Appendix N
Draft EIS Comments and Responses

APPENDIX N DRAFT EIS COMMENTS AND RESPONSES

N.1 PUBLIC AND AGENCY COMMENT SUMMARY

Map of Historic Eagle Nest Locations

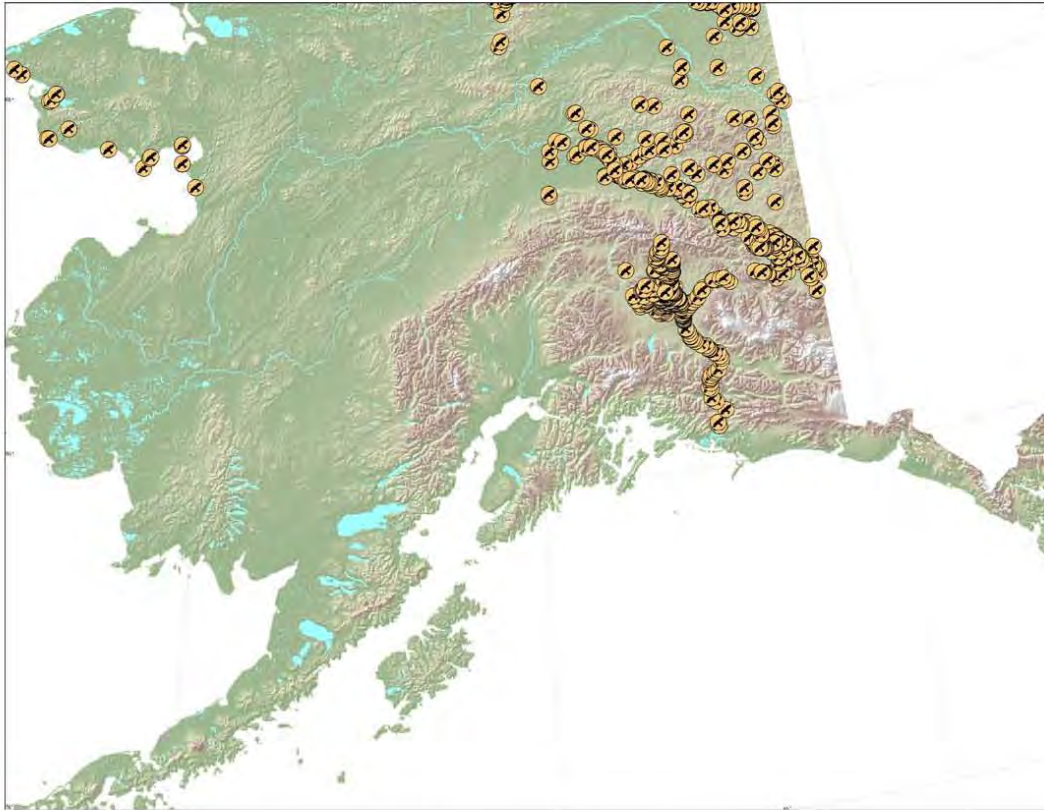
Page 3-49, Lines 25-29, Section 3.1.8.3.1 Alternative A: The Final EIS needs to ensure that the proposed Fox 3 and Paxson MOAs include the 3,000-foot AGL overflight buffer over the Nelchina Caribou Herd Calving Grounds (represented in Figure 3.5 on page 3-41) annually from May 15 to June 15. This also corresponds with Wolfe et al. 2000, who recommends minimizing disturbance during critical stages (i.e., calving season) when cows were the most susceptible to elevated energy requirements.
